RE: Response to Third Technical Notice of Deficiency (TCEQ Tracking No. 30295149)
Greater El Paso Landfill (Type I)
Major Amendment Permit Application
TCEQ Permit Number MSW 2284A
El Paso County, Texas

APPENDIX III.B – SURFACE WATER DRAINAGE REPORT

CITY OF EL PASO, TEXAS
GREATER EL PASO LANDFILL MAJOR
AMENDMENT
PROJECT NO. 155488

Open Channel Energy Dissipator – Trapezoidal Channel (Low-Water Crossing)

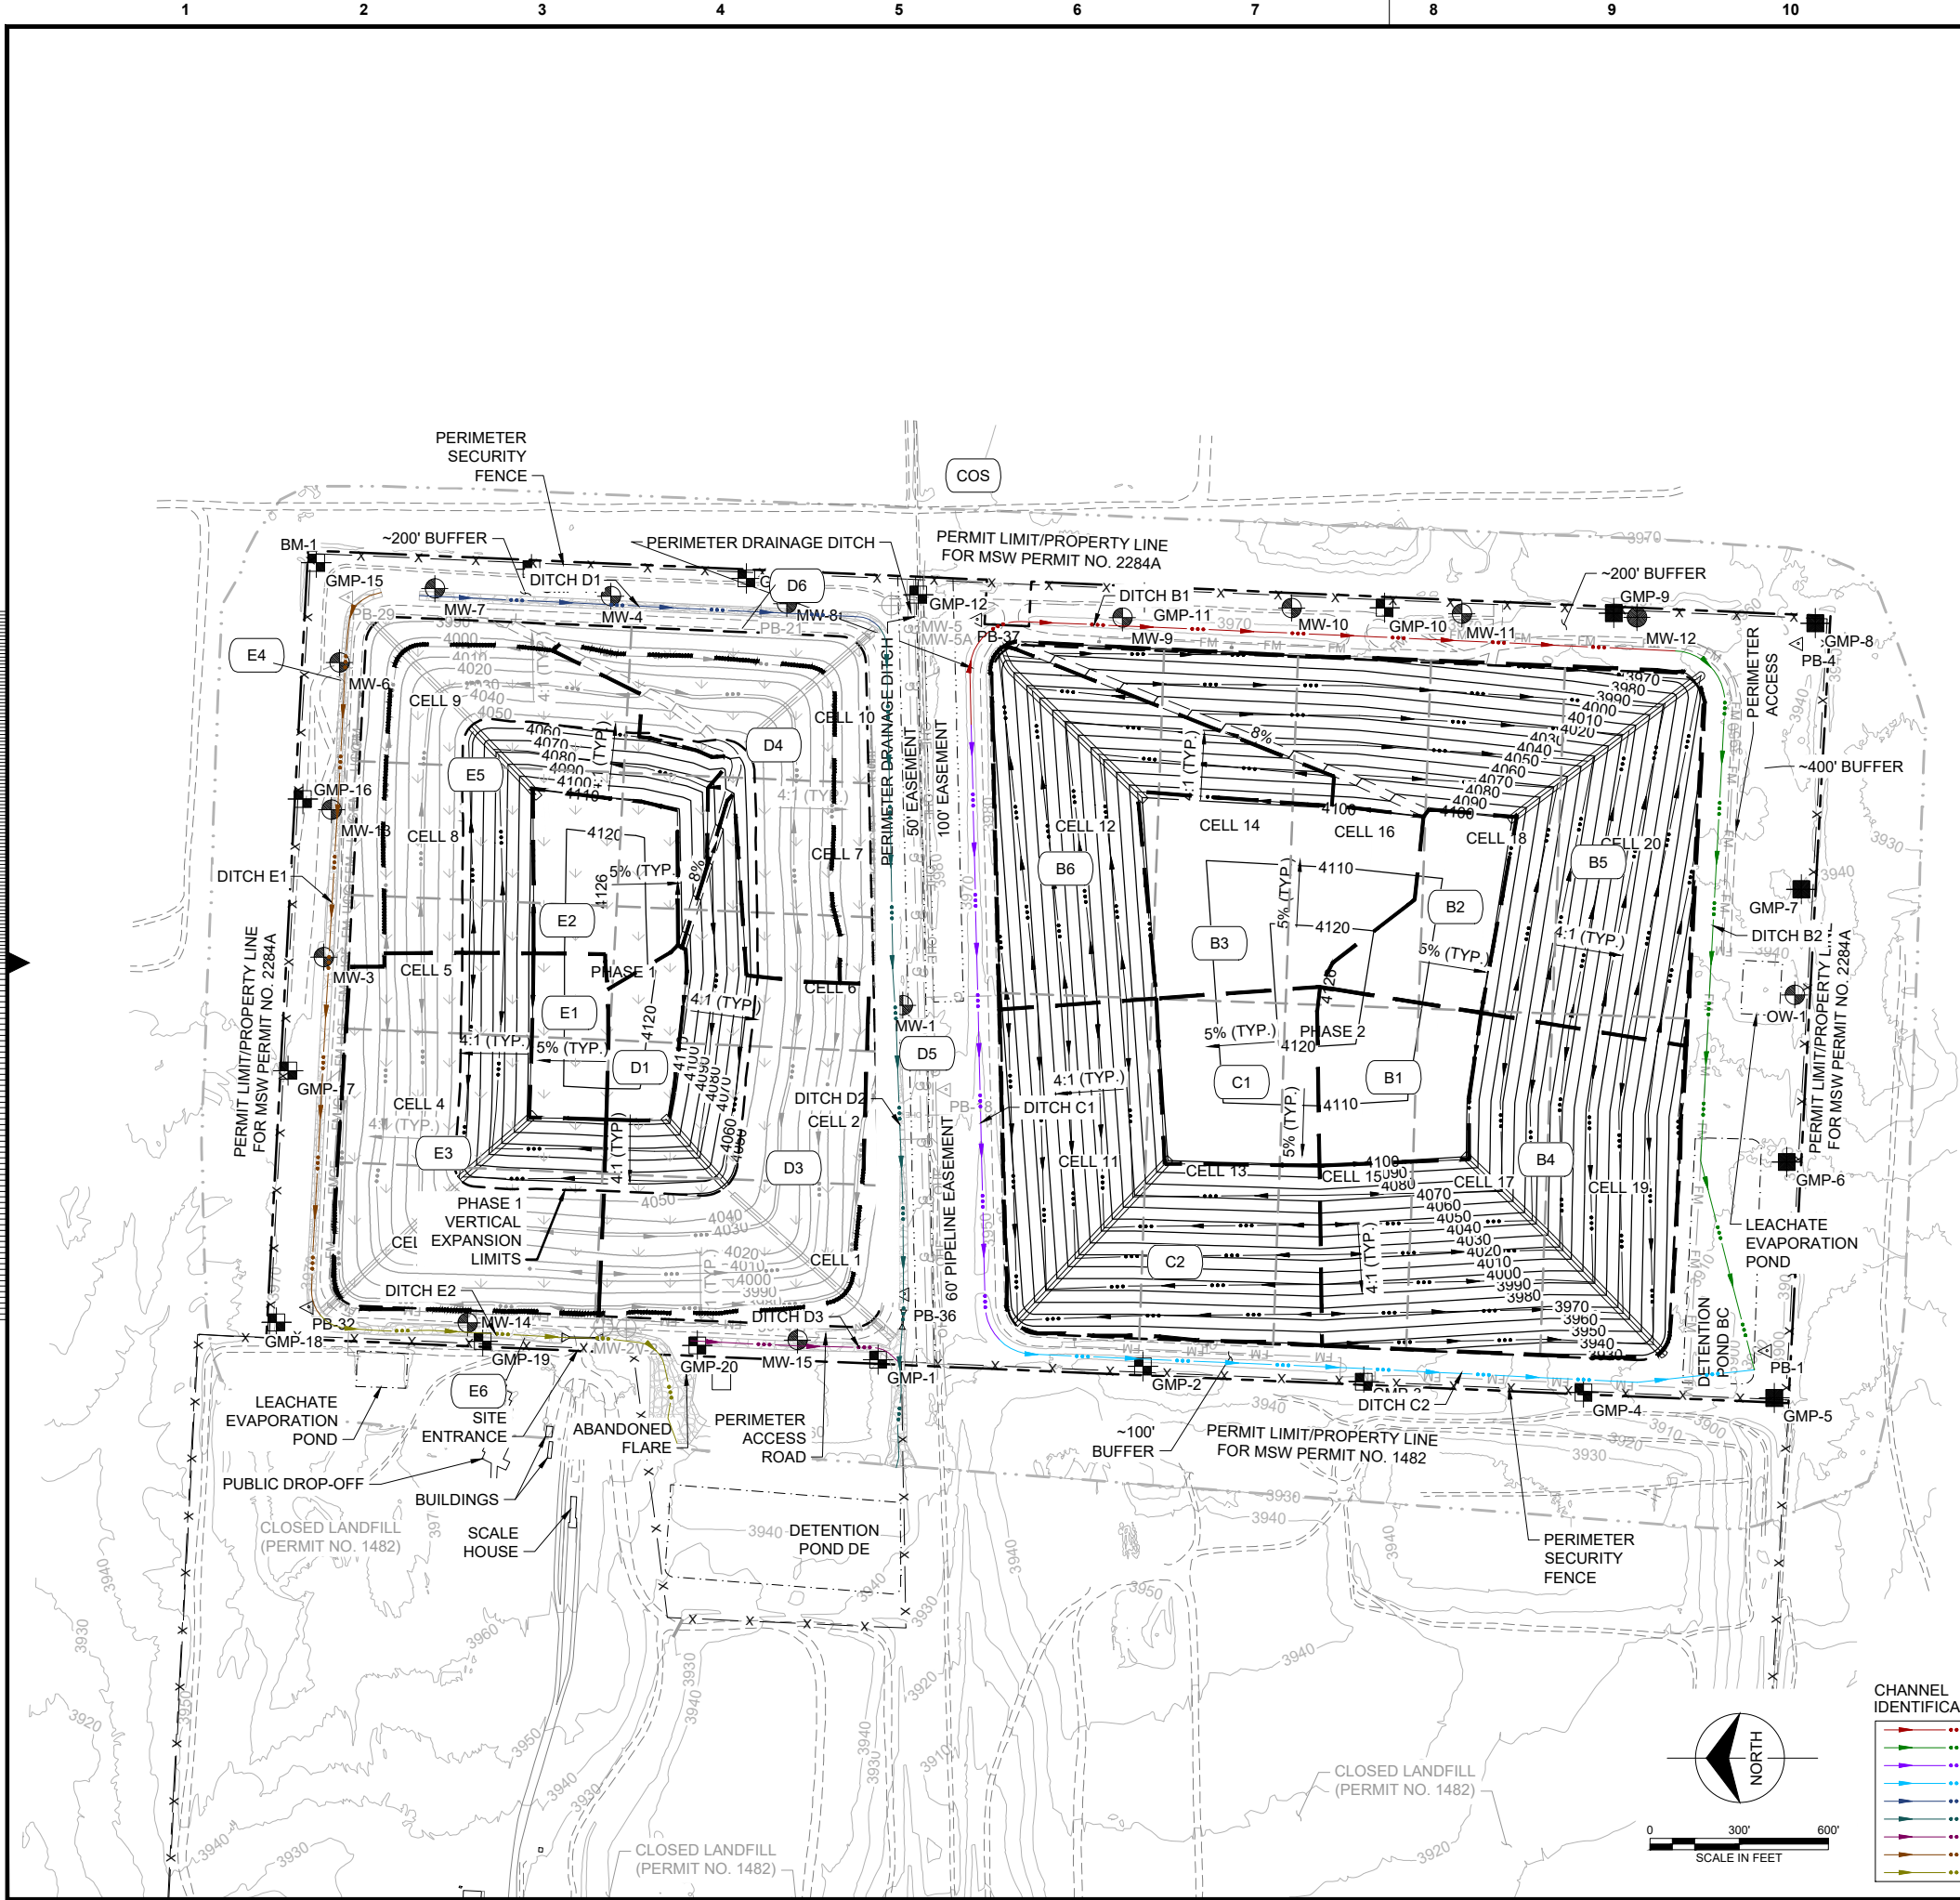
- d. Low water crossing structure: As indicated on Detail 1 on Drawing III.B.6, the calculations start on page III.B.129 and the “Low Water crossing” specifically on III.B.186.5.
- e. Water energy dissipator: As indicated on Detail 6 on Drawing III.B.6, the calculations start on page III.B. 211.1.
- f. Spillways: Spillways were modeled in HEC-HMS as a function of the Outfalls for Basins BC and DE. Results provided on page III.B.87, 88, 112, & 113 and additional calculations are included on pages III.B.186.1-186.4.

Top Width T (ft)	13.344
Area A (ft ²)	14.257
Wetted Perimeter P (ft)	13.974
Hydraulic Radius R (ft)	1.020
Velocity V (ft/s)	12.359
Hydraulic Depth D=A/T (ft)	1.068
Normal Depth Residual $f(y)=Q-(1/n)A R^{2/3} S_0^{1/2}$	0.000
Unit Discharge q per top width (cfs/ft)	13.205
Froude Number $Fr_1 = V/\sqrt{g \cdot D}$	2.108 Supercritical
Approx. Sequent Depth y ₂ (ft) [uses Belanger with Fr ₁ and y ₁]	3.370

Minimum Basin Length (ft) (per HEC-14)	18.824	< 30' Road Width
--	--------	------------------

Crossing Contains Hydraulic Jump
SEE DETAILS ON DRAWING III.B.6.

- The chute delivers supercritical flow to the crossing ($Fr_1 \approx 2.1$), the dissipators reduce the Energy of the flow and reduce it to sub-critical prior to discharge into the basin or perimeter channels.
- The two dissipator rows act as perforated sills that force and stabilize the hydraulic jump on the slab.

POND DE OUTFALL AND SECTIONS

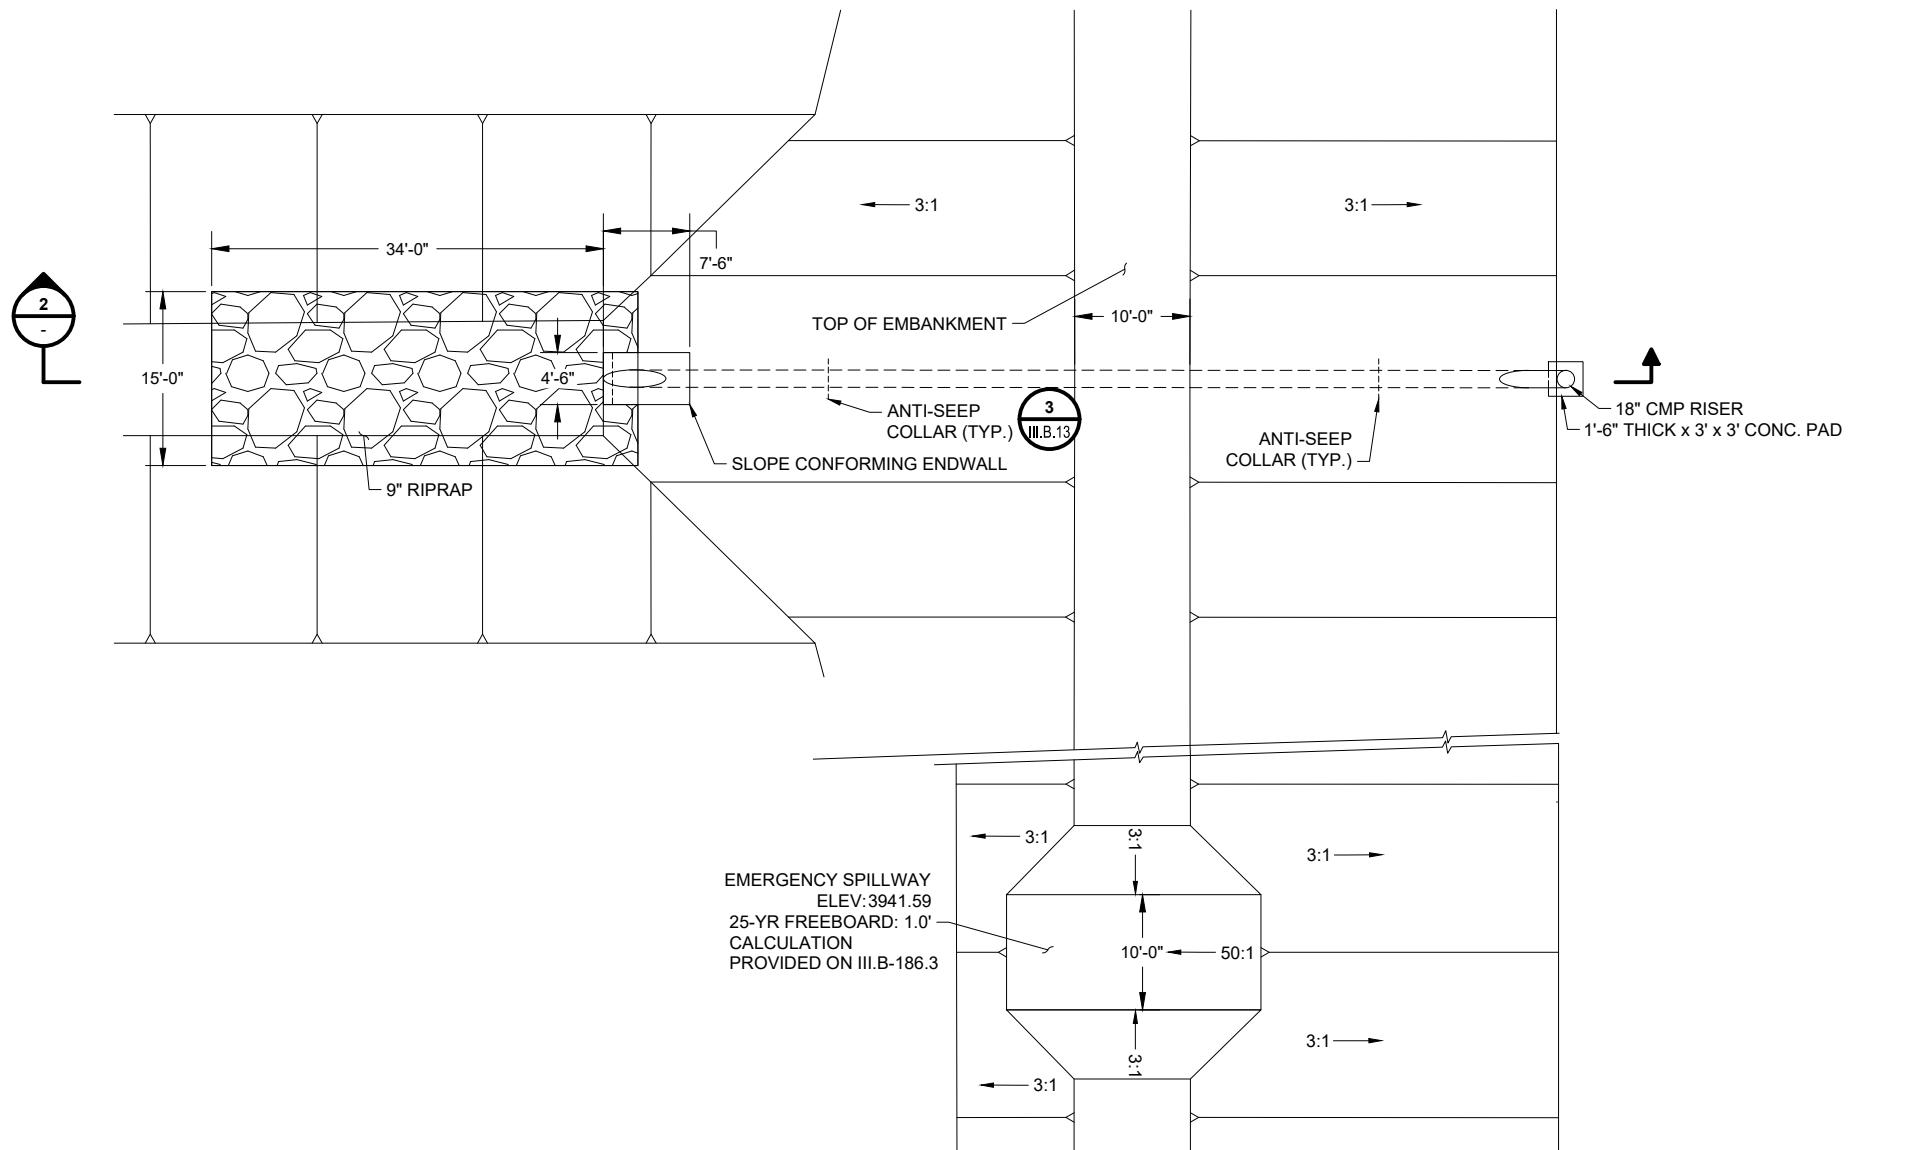
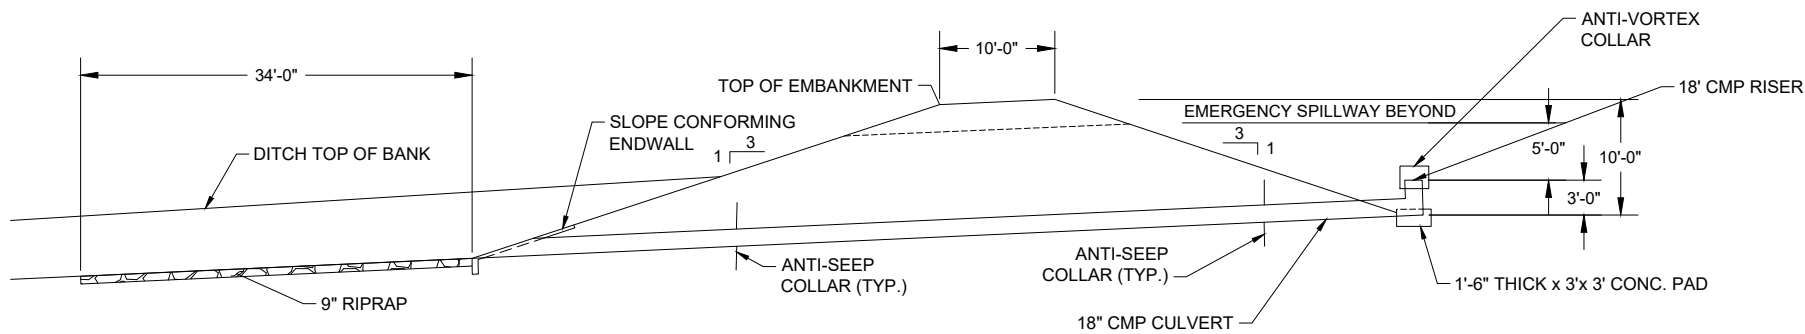
NOD ID 2, Citation 330.63(c)(1)(D)(ii) and 330.57(h)(3), Location Part III, Attachment III.B: Revise Drawings III.B.5, III.B.6, III.B.13, and III.B.14 to provide cross-sectional drawings per hydraulic calculations, drawn to an engineering scale.

Response: Cross section drawings are provided to scale on Drawing III.B.5, III.B.6, III.B.13, and III.B.14. It is noted that the scale on Drawing III.B.5 was inadvertently left off for NOD2 and a revised draft drawing is provided. Calculations were completed for the worst-case scenario (e.g., greatest flow) for each of the structures to verify sizing. This means for all top berms including Phase 1, the size/capacity of the berm was sized based on the area B3 which has the largest contributing area to the berm. For the interceptor/side slope ditches, an area from sub-catchment area B5 was used. Sub-catchments B2 & B5 together were used to check the size of the letdowns.

Normal Depth 8.3 in < 24 in Spillway Depth, See Drawing III.B.14.
